STATE OF TENNESSEE
 TENNESSEE DEPARTMENT OF EDUCATION

**INVITATION FOR BID # 33101-11729
 AMENDMENT # 1
 FOR YORK SECURITY CAMERAS**

DATE: JANUARY 28, 2021

**YAI
2016-2017
ROOM
ASSIGNMENTS**

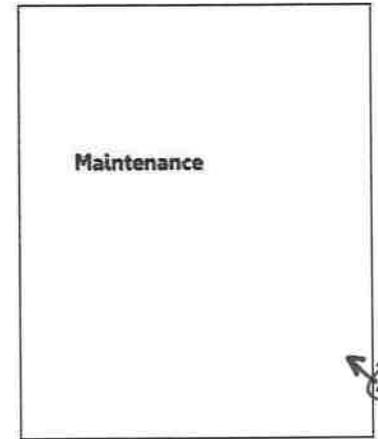
18. Is there a sight map available or this project?	Attached is the only map available.

#1
main bld.
(Houses MDF: no work to be done here; All
switch installs in the four (4) IDF's which
are marked and circled)
